#### **CERTIFICATE OF APPROPRIATENESS**

**Proposal:** Alteration – Replace Front Porch

HPO File No. 2021\_0134

**ITEM #B11** 1128 Walling St Norhill

### **Proposed Front Porch**

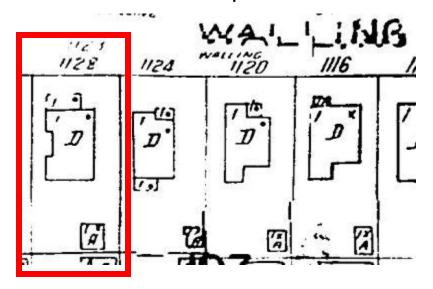
(4)	The proposed activity must preserve the distinguishing qualities or character of the building, structure, object or site and its environment;  The proposed alteration will lose the brick columns and wall that are characteristic of this type of porch built in the 1920s in Norhill.

(5)	The proposed activity must maintain or replicate distinctive stylistic exterior features or examples of skilled craftsmanship that characterize the building, structure, object or site; The proposed alteration will lose the brick columns and wall that are characteristic of this type of porch built in the 1920s in Norhill.

Recommendation: Approval with conditions: The condition that the applicant rebuild and restore the

distinctive brick columns with opening in the columns with the brick semi-arch details; rebuild the brick walls between the columns; and rebuild the stand alone brick pedestal
